NUCLEAR REGULATORY COMMISSION

Title: Advisory Committee on Reactor Safeguards
589th Meeting

Date: Thursday, December 1, 2011

1, Levy County Units 1 and 2 Combined License Application; 2, revised Branch Technical Position regarding Concentration Averaging and Encapsulation of Low-level Radioactive Waste

Grouting Program and Seismic Wave Velocities

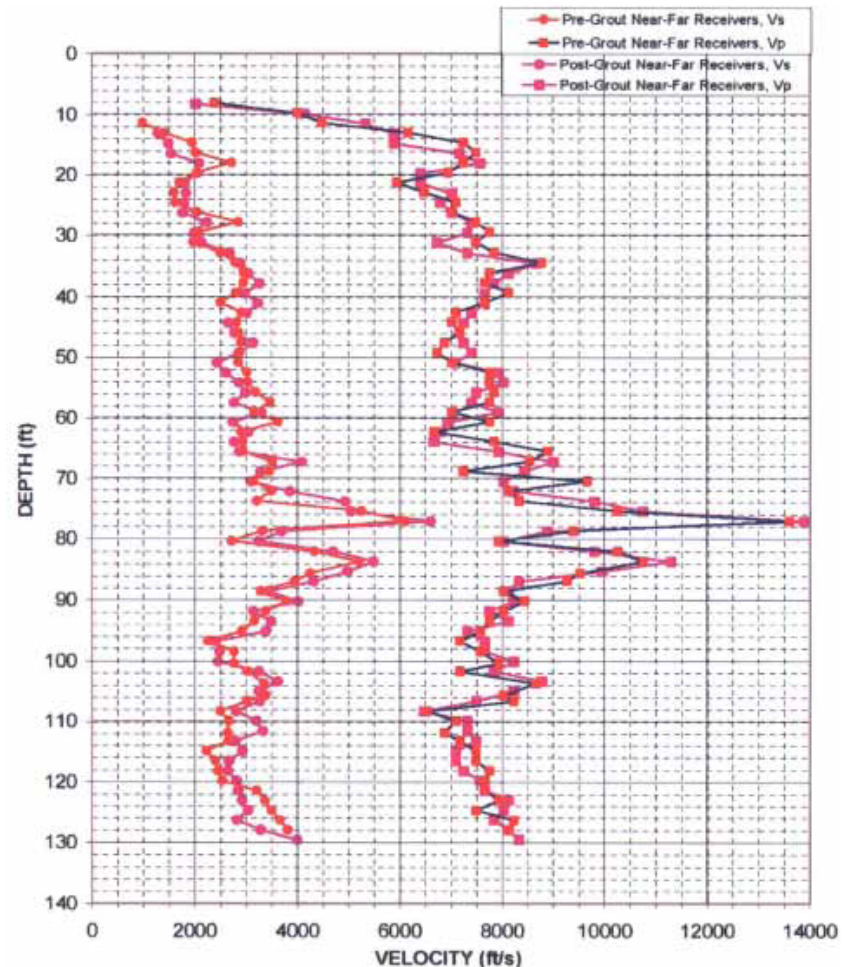
- Issue: Staff was concerned that seismic wave velocities are the same before and after the applicant's grouting program.
- Resolution: Applicant's grout test program measured velocities pre- and post-grouting. Measurements demonstrate that the grouting program do not alter the measurements of seismic wave velocities. Therefore, this issue is resolved.

Confirmatory Analysis of Site Response Calculations

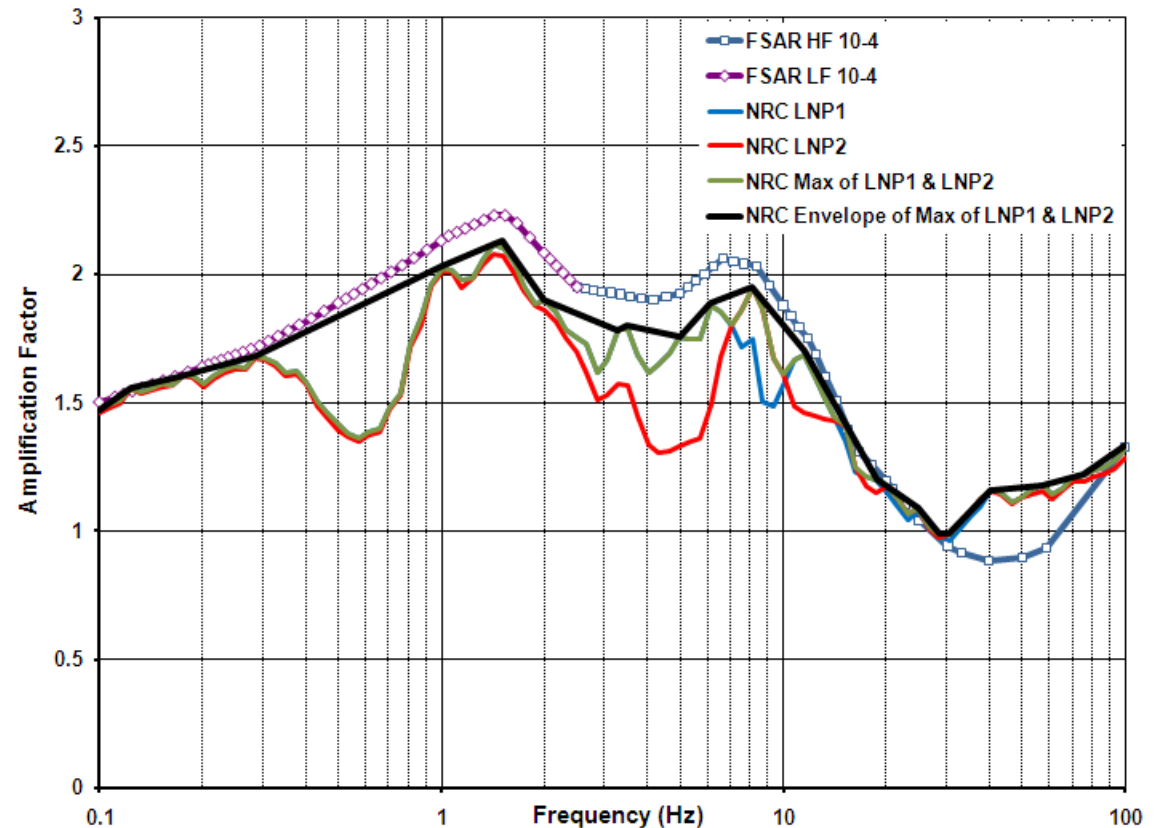
- Site amplification functions were calculated for both LNP Unit 1 and 2 profiles and later enveloped to provide a conservative estimate.
- NRC Staff performed an independent site response analysis and confirmed the applicant's results.

Applicant's functions equal to or exceed the staff's in frequency ranges 0.1 to 30 Hz and 80 to 100 Hz. The staff's function exceeds the applicant's in frequency range 30 to 75 Hz. This exceedance is not significant, and is related to limitations of the different methods applied. (AFSER Figure 2.5.2-12)
